Case Number: R18077

CASE COMMENTS:

Existing Stormwater Asset Map possibly affected by the Proposed Development

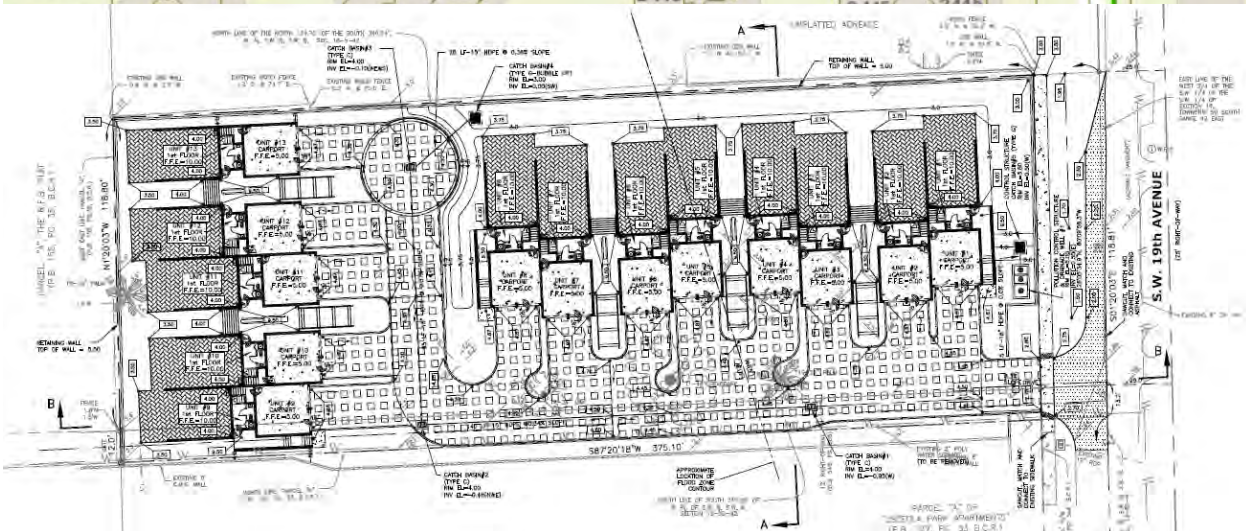
The City owns and maintains stormwater infrastructure adjacent to the proposed development as shown with green line work in the map provided at the end of this report. **Civil plans shall be revised to show the City's stormwater inlet ID #s as identified in the map provided at the end of this report.** The following comments pertain to possible impacts of the proposed development and/or construction activities to the existing condition of the City's stormwater assets. The applicant shall provide an itemized response letter addressing the following comments:

1. Please provide (or revise if already submitted) an erosion, sedimentation, and stormwater pollution prevention plan (**SWPPP**) showing the adjacent City's existing stormwater system as shown in the survey and to the limits shown with green line work in the storm map provided at the end of this report. A copy of the approved SWPP shall be at the construction site from the date of demolition initiation to the date of final construction activities.

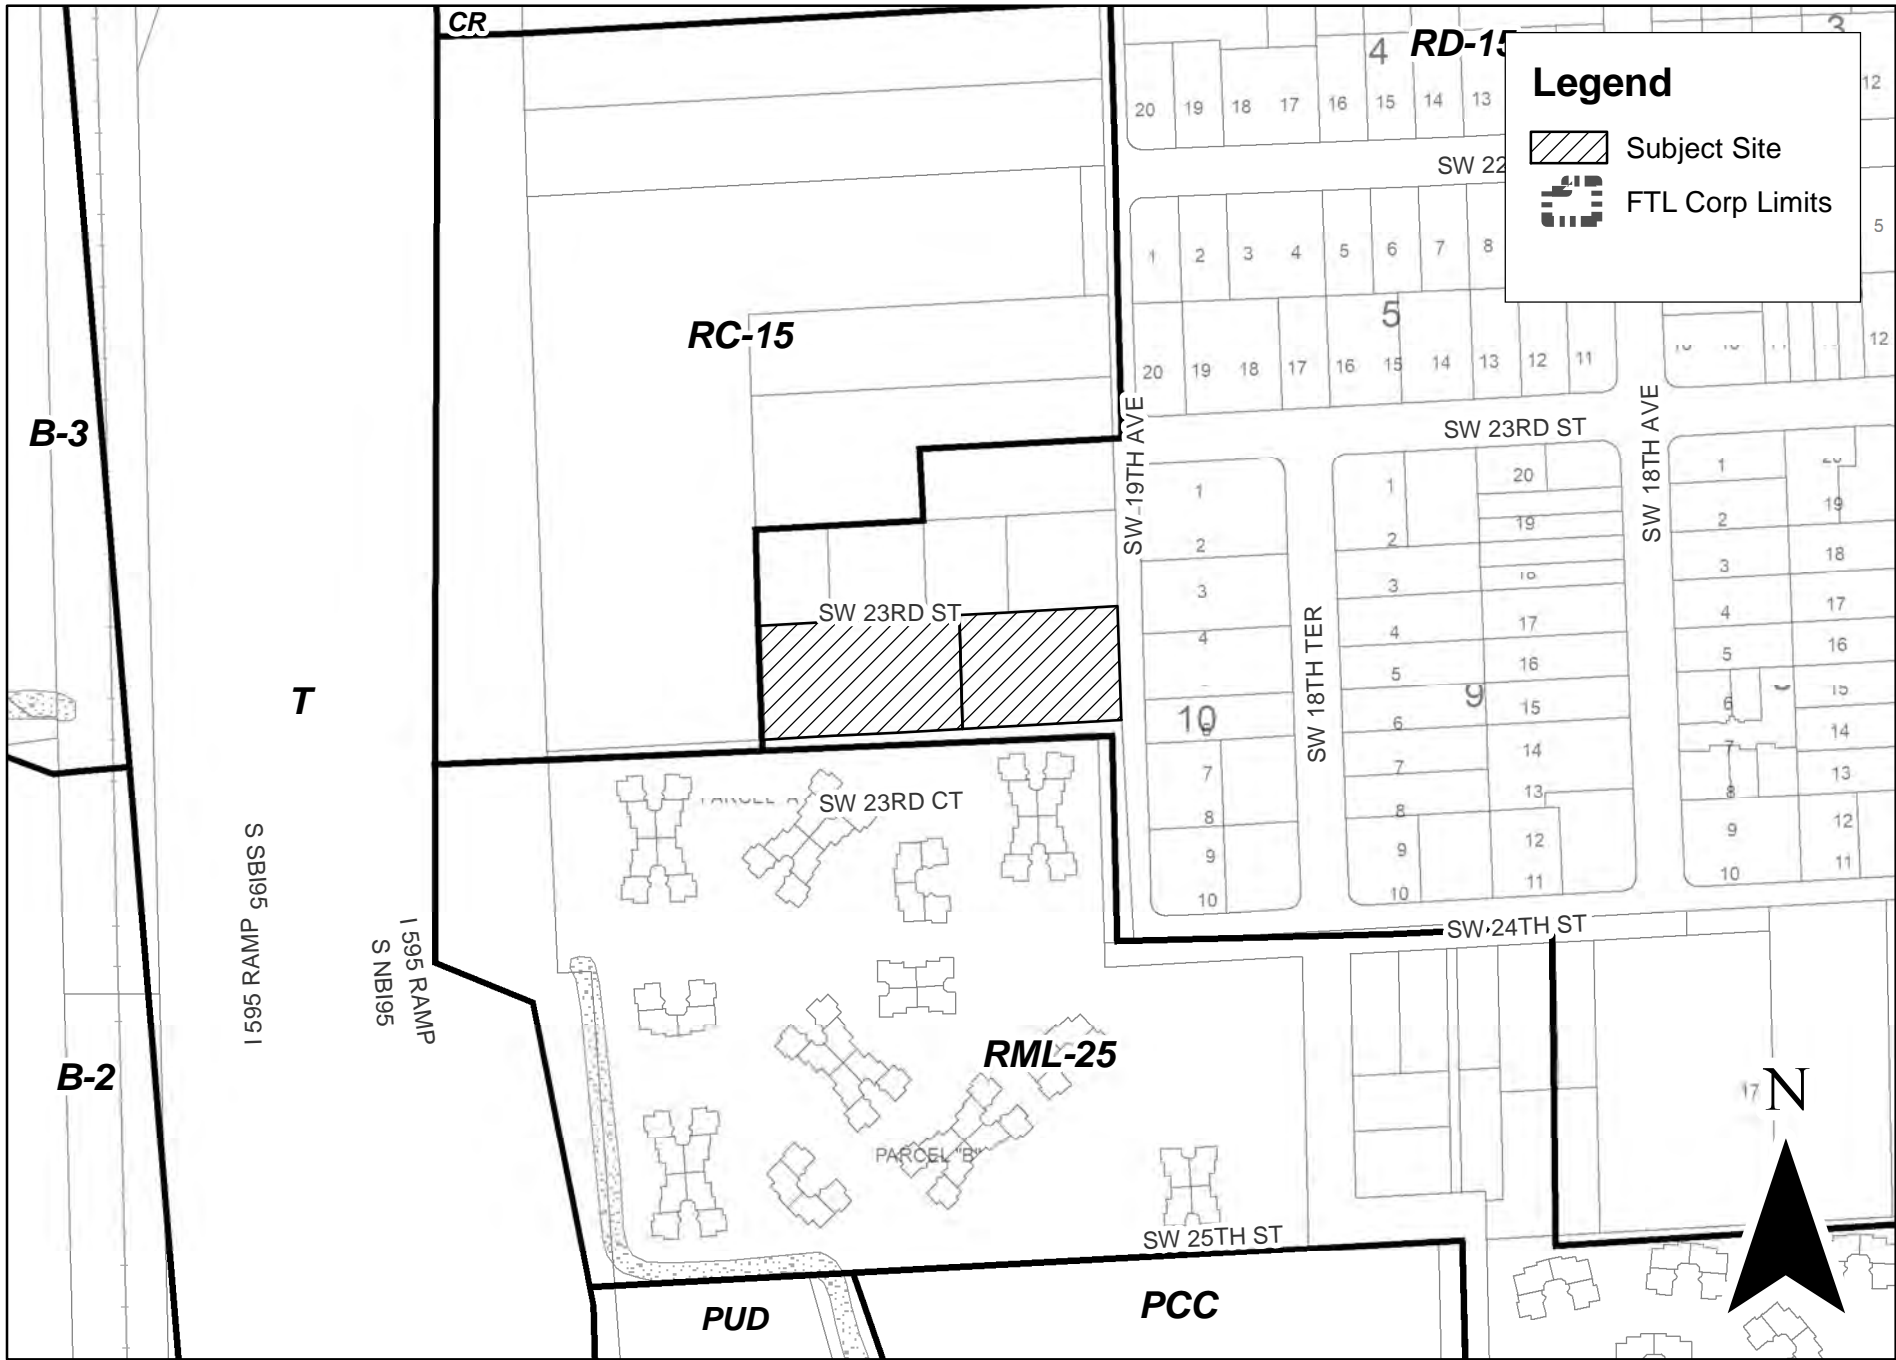
- a. On the plan sets, change "townhomes" to "cluster development."
 - b. On sheet G-2, the site plan needs to reflect the building at ground level. Currently, the carport is represented from the floor above, which makes it look like the carport cannot fit two cars. Please clarify and add dimensions.

- c. Per ULDR Section 47-20.2, Parking and Loading zone requirements, provide designated guest parking at 0.25 spots per dwelling unit.
 - d. Per ULDR Section 47-20.10.A, a standard parking space shall be a minimum of 8' -8" by 18'. Provide a detail of the carports with the dimensions to ensure two vehicles can safely fit. Also, provide that dimension on the site plan.
